## EXPERT ADVICE - VEP WESTERN EMPLACEMENT

ATTENTION:	Mr Steve O'Donoghue, NSW Dept of Planning Infrastructure and Environment	
FROM:	Hugh Middlemis, Principal Groundwater Engineer, HydroGeoLogic	
REFERENCES:	12 March 2020	DPIE ref: Vickery Extension Project Groundwater Assessment
	HGL job#: 61.073	
SUBJECT:	Vickery Extension Project groundwater assessment - Western Emplacement

Figure 8b: Simulated Water Table at the End of 100 Years' Recovery (1% Rainfall Recharge of Waste Emplacement)  
 (Source: HydroSimulations)

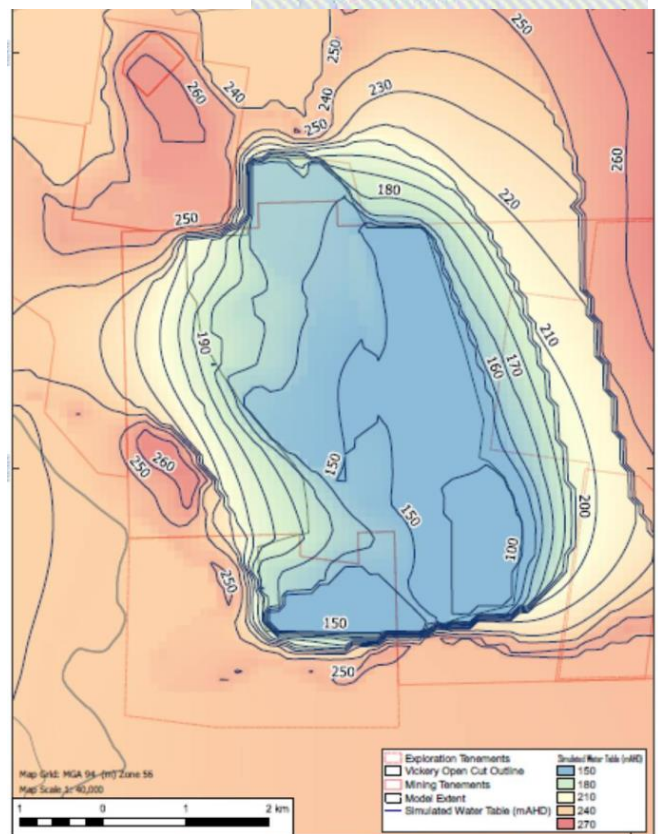
- assuming that closure will involve a final void at the south-eastern corner of the VEP, the modelled water table at 100 years after the end of mining shows that the long term final void groundwater 'capture zone' extends across the Western Emplacement over the alluvium embayment (VEP Submissions Report, August 2019, Figure 8b); this means that seepage from the Western Emplacement would indeed flow towards the final void sink rather than towards the alluvium.
